ASSESSMENT REPORT

Section 75W Modification Visy Kraft Pulp and Paper Mill, Tumut – Truck Refuelling Facility (DA 06/98 MOD 3)

Figure 3: Refuelling Facility Plan

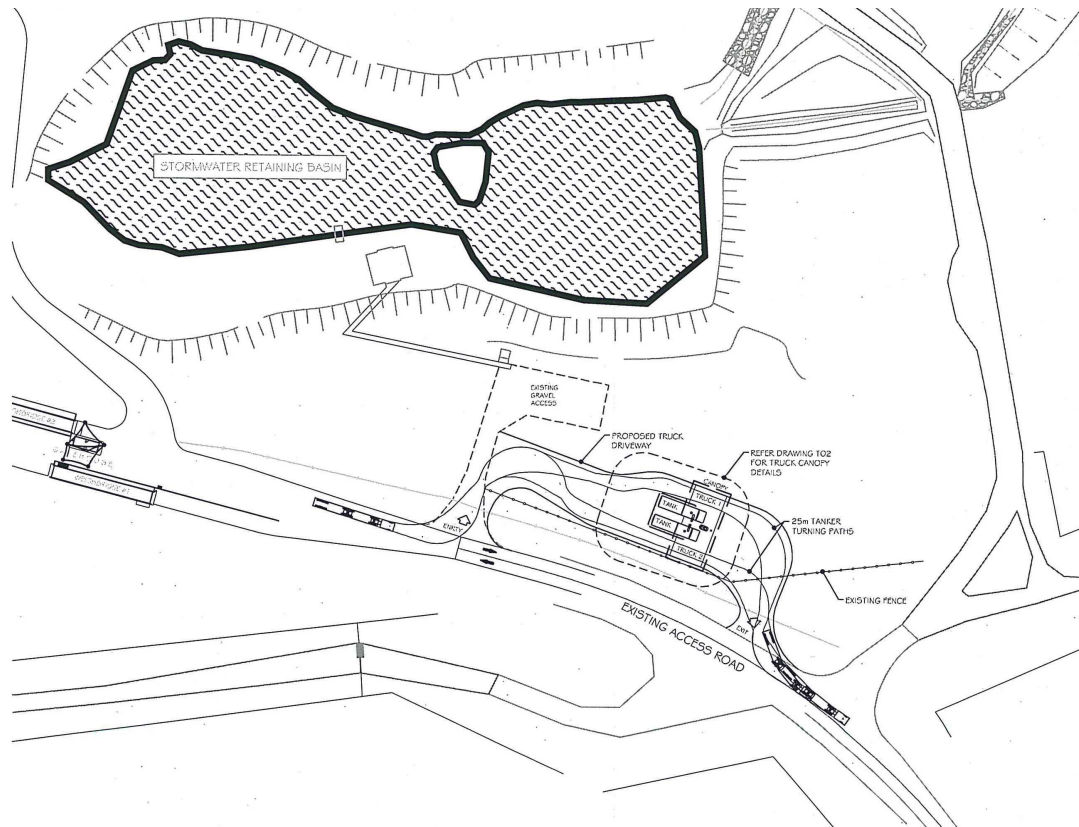
Tumut Shire Council (Council) did not object to the installation of the refuelling facility and advised that it would rely on the EPA to address any environmental concerns. Notwithstanding, Council did provide comment on truck manoeuvrability in the vicinity of the refuelling facility and the T-intersection at Gadara Road suggesting that vehicle turning paths for a 36m articulated vehicle should be provided to ensure there are no safety concerns.

Issue	Assessment	Recommendation
	significantly impact the internal traffic and access arrangements on site. Notwithstanding, the Department has recommended that prior to commencement of any construction works associated with the refuelling facility, Visy be required to submit detailed design plans and vehicle turning paths for the access road servicing the facility. Further, that Visy submit a revised Traffic Management Plan (TMP) for the site that incorporates the proposed modification.	submit a revised Traffic Management Plan that incorporates the refueling facility operations and address driver conduct.
Wastewater	- The refuelling area would be covered by a canopy to divert uncontaminated rainwater into stormwater drains thereby minimising the amount of rainwater entering the wastewater treatment system. - The containment area under the canopy would be graded to direct any wastewater from the refuelling area into a wastewater treatment system. - The wastewater treatment system is designed to separate the oil and grease from the water before the treated wastewater is discharged to a nearby drain and then off site. - The EPA advised that under the requirements of the POEO Act, it would be necessary to licence the discharge from the facility. An additional discharge point would need to be added to Visy's EPL with a limit for oil and grease of 10 milligrams per litre and a quarterly monitoring frequency. - Visy has confirmed that treated wastewater, once passed through the treatment system, would discharge back into the stormwater culvert which is located approximately 50 metres from the refuelling area and then off site. As such Visy would be required to submit an application to the EPA to amend their EPL. - The Department and EPA are satisfied that wastewater from the proposed modification would be adequately managed through the installation of the proposed wastewater treatment system and a licensed discharge point.	Recommended conditions require Visy to: ensure that any discharge from the refuelling facility is licensed with the EPA.
